NUCLEAR REGULATORY COMMISSION

Title: Advisory Committee on Reactor Safeguards
Reactor Fuels Subcommittee

Date: Wednesday, December 15, 2004

MOX Project Overview

CS-01: Red Oil
Pressure Vent Relationship

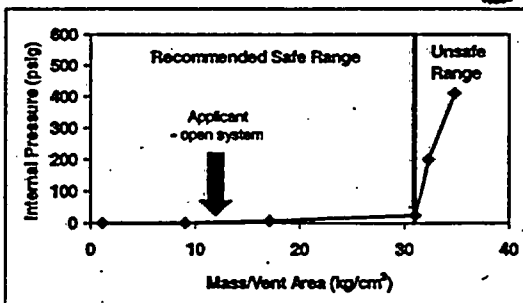
7 In the open system, it has a safety
8 function to avoid pressurization, and a design basis
9 has been identified by the applicant. Okay? And I'll
10 get to that in a little more detail in a moment, but
11 that basically defines the size of the vent on the
12 vessel.

CS-01: Red Oil Pressure Vent Relationship

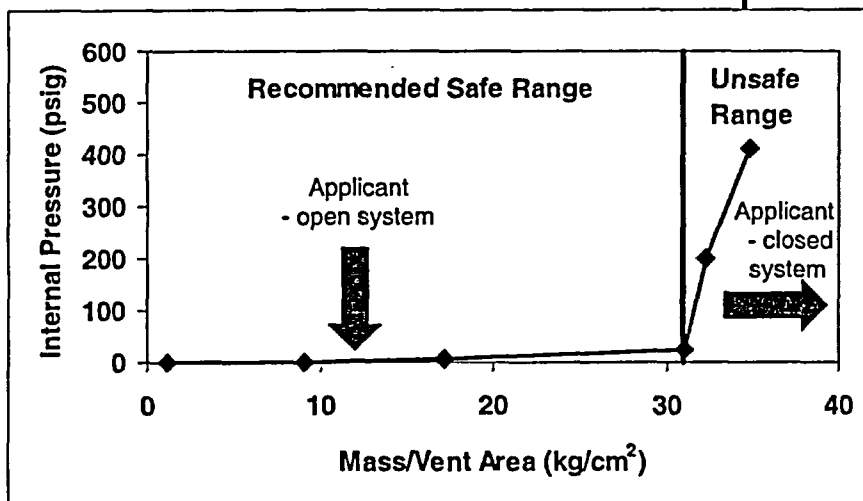
7 MR. MURRAY: Well, let me just clarify
8 something. The applicant has committed to an
9 experimental program to essentially define and, if you
10 will, make sure that the temperature value 125 degrees
11 Centigrade, for example, is reasonable and appropriate
12 as a design basis.

15 MR. MURRAY: Okay. Here it is. This is
16 a commitment they've made. The applicant will define
17 the reaction kinetics in more detail, quantitatively,
18 determine effects of impurities, and then from that
19 experimental data probably as part of testing
20 establish some operational limits and set points.
